1601 LeMoyne Ave Cuse Car Care, LLC project roadmap

<i>R-24-26</i>	<i>Staff Report – July 8, 2024</i>
<i>Application Type:</i>	Resubdivision
<i>Project Address:</i>	1601 Lemoyne Avenue (Tax Map ID: 004.-05-03.0), 1611 Lemoyne Avenue To City Line, (Tax Map ID: 004.-05-02.0), 1585 Lemoyne Avenue (Tax Map ID: 004.-05-04.1)
<i>Summary of Proposed Action:</i>	<p>The Applicant proposes to merge three lots (1601 Lemoyne Ave, 1611 Lemoyne Ave, and 1585 Lemoyne Ave) into one new lot. The parcels are also across with municipal boundary in the Town of Salina.</p> <p>The applicant intends to build a two-story addition to the existing 1 story car repair shop upon the approval of resubdivision</p> <p>New lot 4A (only the portion in the City of Syracuse): 0.57 Acres/25,003 SF</p>
<i>Owner/Applicant</i>	Michael Pierce, Cuse Car Care LLC (Owner) Jared McCormick, Daniel Manning-Architect, PLLC (Applicant)
<i>Existing Zone District:</i>	Mixed-Use Transition, MX-3 Zone District

<u>SP-24-09</u>	Staff Report – July 8, 2024
Application Type:	Special Use Permit
Project Address:	1601 Lemoyne Avenue (Tax Map ID: 004.-05-03.0), 1611 Lemoyne Avenue To City Line, (Tax Map ID: 004.-05-02.0), 1585 Lemoyne Aven

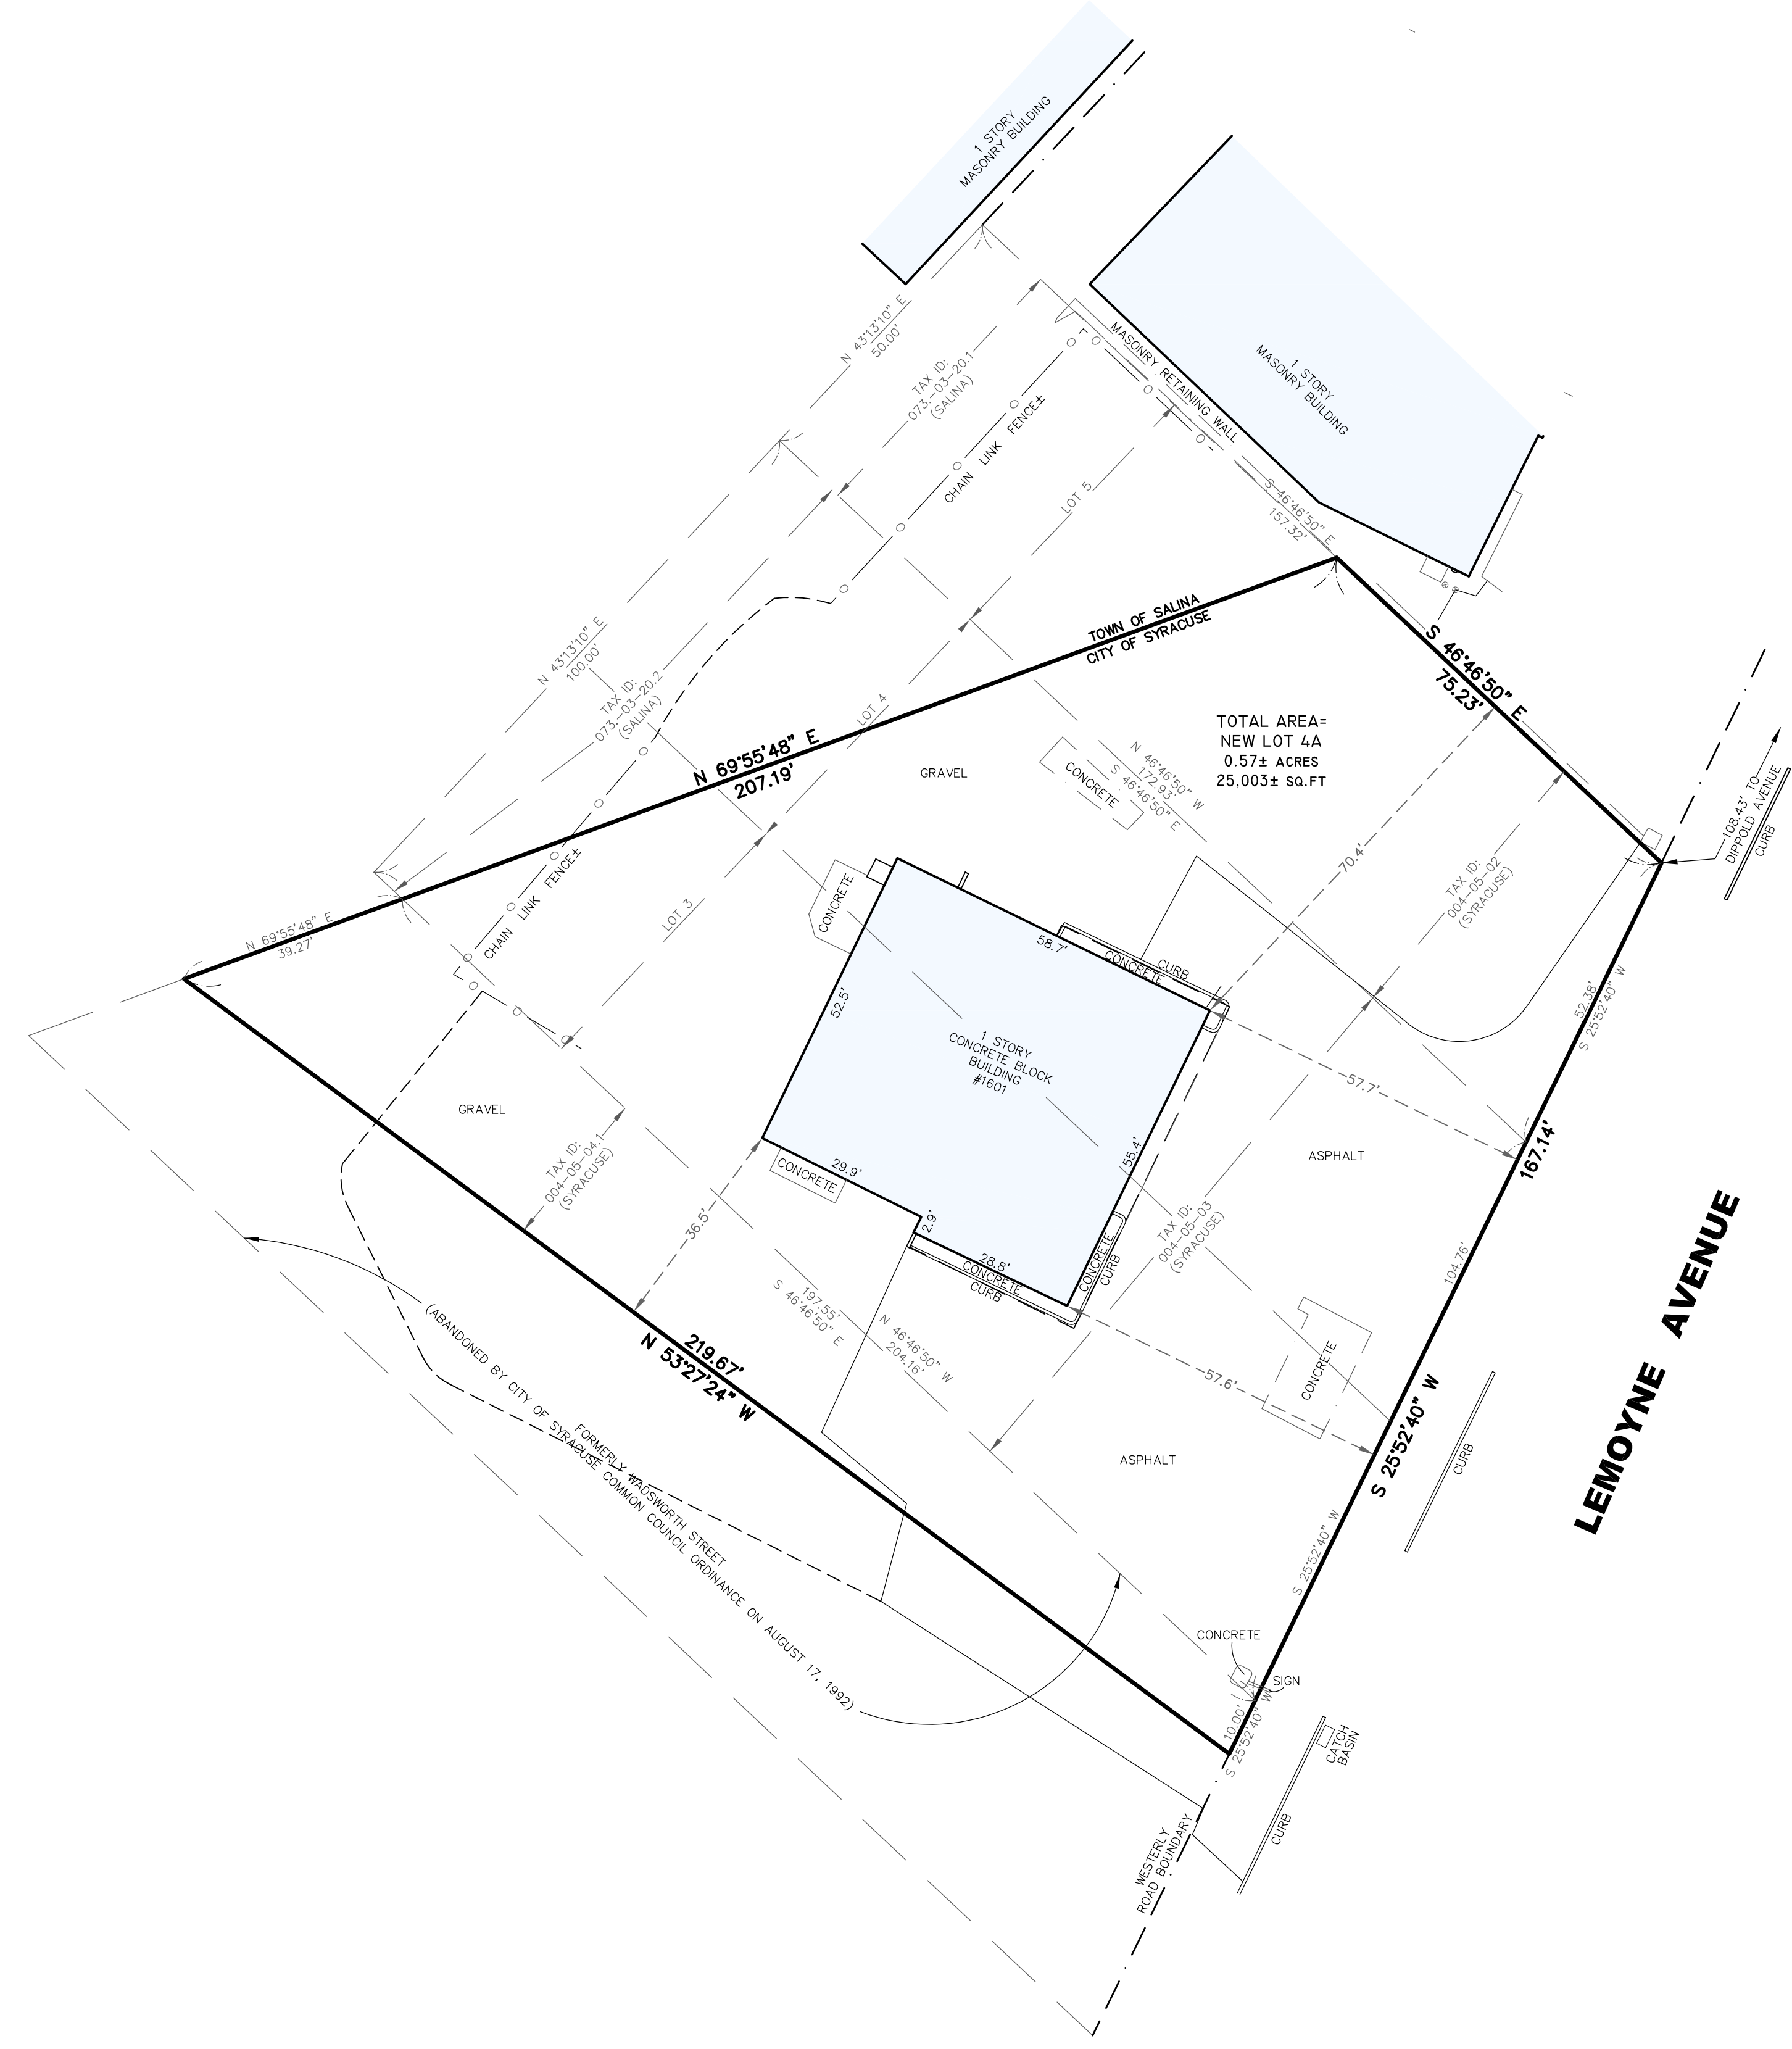
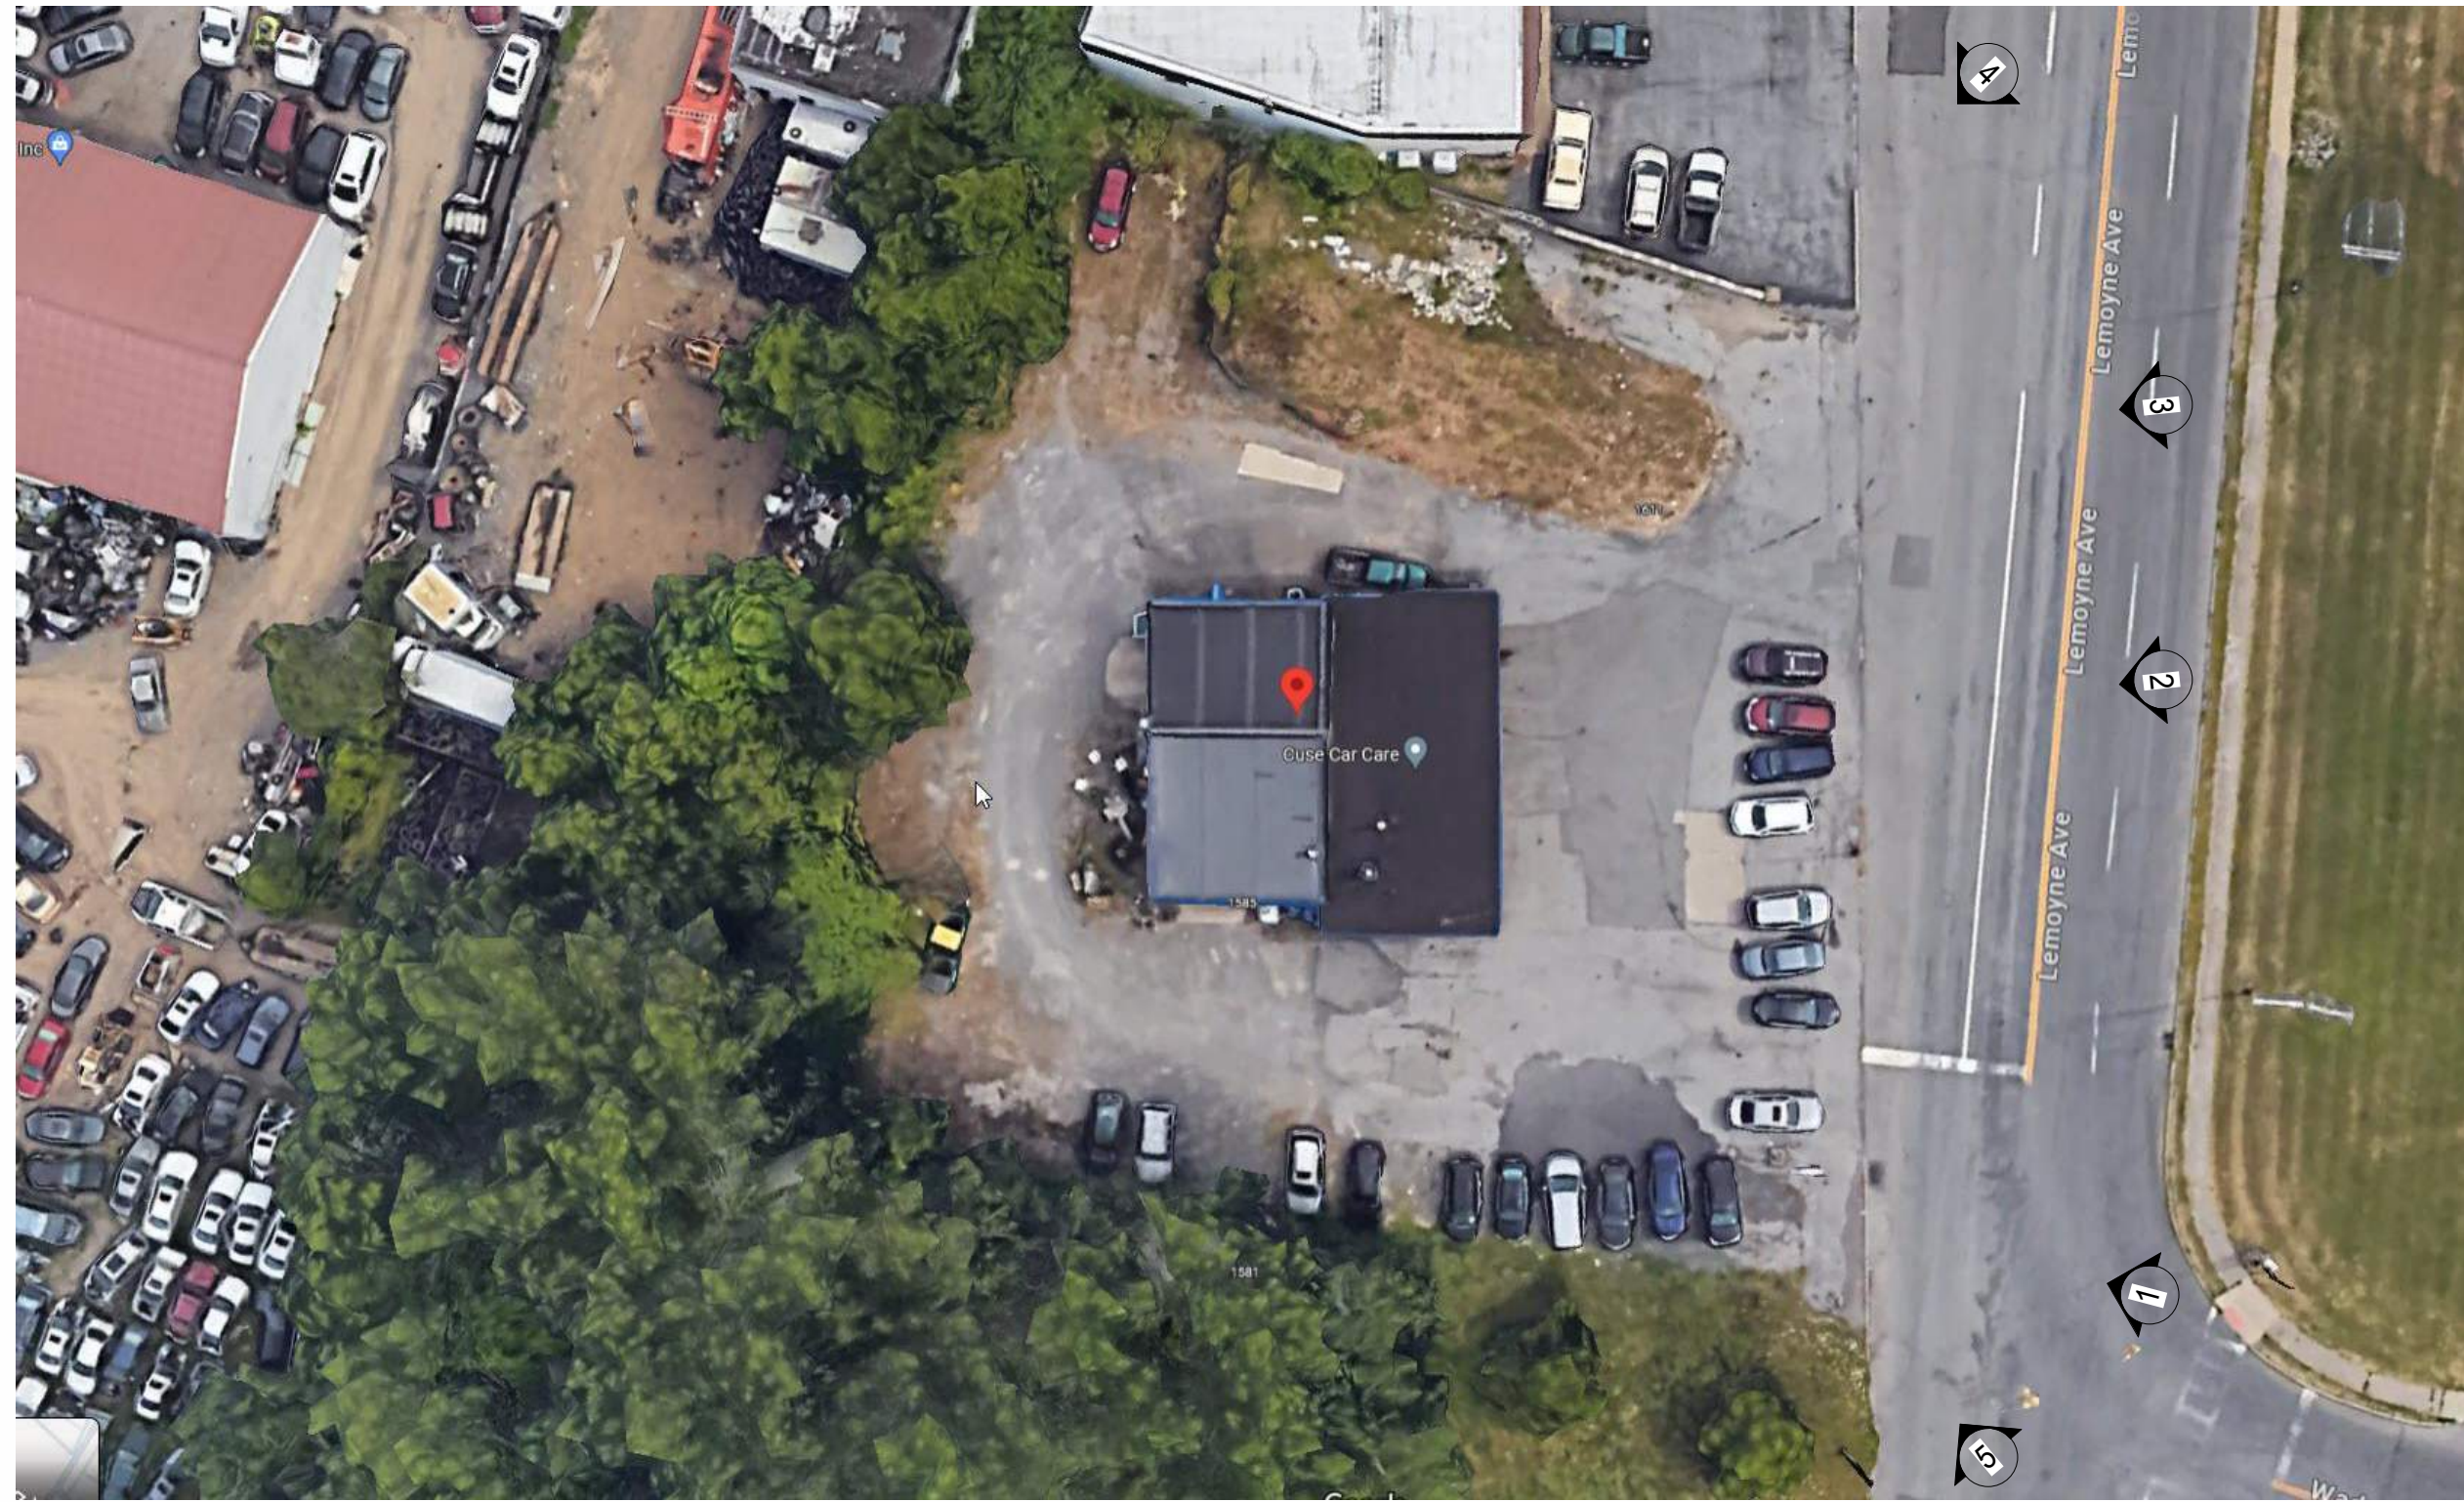
- WHEREAS, per the Cuse Cars, LLC Subdivision Plan dated 3/22/23, the applicant is proposing to combine the three City of Syracuse parcels into one new 0.57-acre lot; no changes were proposed to the two Town of Salina parcels, but the Site Plans depict some of the proposed work to occur within the Town; and

Approval	Status	Status Date	Reviewer	Comments
Zoning Planner	Pending	04/17/2024		The proposed lot complies with the Rezone lot design standard in MX-3
Eng. Mapping - Zoning	Approved	04/23/2024	Ray Wills	-The bearings for the streets in question cannot be confirmed or denied via Official City ROW records. As they lie in an area outside of the plats available.
Finance - Zoning	Internal Review Complete	04/18/2024	Veronica Voss	1585, 1601 and 1611 Lemoyne tax bills are all paid in full; no taxes due.
Eng Stormwater (SWPPP)-Zoning	Internal Review Complete	04/26/2024	Mirza Malkoc	<ul style="list-style-type: none"> Proposed site elevations shall be graded to prevent stormwater sheet flow to adjoining properties & to the City R.O.W. This is just a reminder that a Stormwater Pollution Prevention Plan (SWPPP) is required for review if the total soil disturbance is greater than 10,000sf.
Eng Sewers- Zoning	Internal Review Complete	04/26/2024	Mirza Malkoc	<ul style="list-style-type: none"> Future project is subject to Onondaga County's 1:1 offset. The City requires an offset plan & details for review. Applicant shall submit sanitary flow data to the Engineering Department, the determined offset plan then most likely will require Common Council Approval. Onondaga County Plumbing Control shall review and approve the plans as well.

Eng. Design & Cons. - Zoning	Conditionally Approved	04/26/2024	Mirza Malkoc	<ul style="list-style-type: none"> No objection to re-subdivision. Any future construction/development on this lot will be subject to the City plan review, approval and permitting process as applicable.
Planning Commission	Pending	04/17/2024
